DTB

Date: January 13, 2005
Order No.: P-B-09.20/19
Supersedes:
Group: 09

**SUBJECT: Model 171.456
Engine Performance / Check Engine Light On**

Figure 1

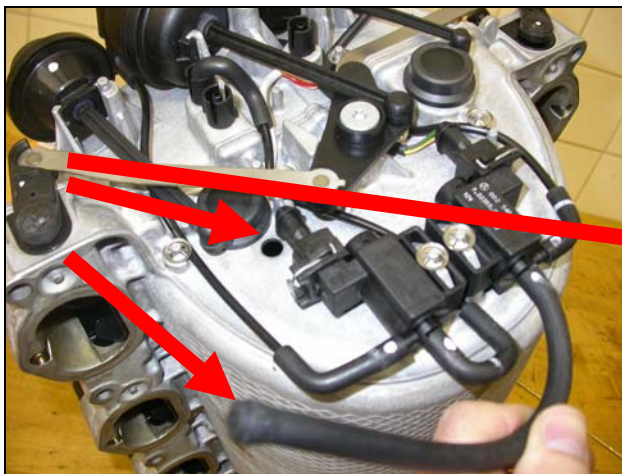
The condition may be caused by the vacuum hose for the vacuum supply for the air routing flaps and turbulence flaps at the intake module being cracked or torn off (Figure 1 and 2). Consequently, un-metered air is entering the engine causing the above condition.

If you receive customer reports in the above model vehicles of engine runs rough at idle, poor performance, hard starting and/or check engine light activated (possible but not limited to one or more of the following codes stored in the engine control unit 0745, 0749, 0632, 0633, 0636, 0637, 0640, 0641, 0644, 0645, 0649, 0653, 0656), exchange the intake manifold module to resolve.
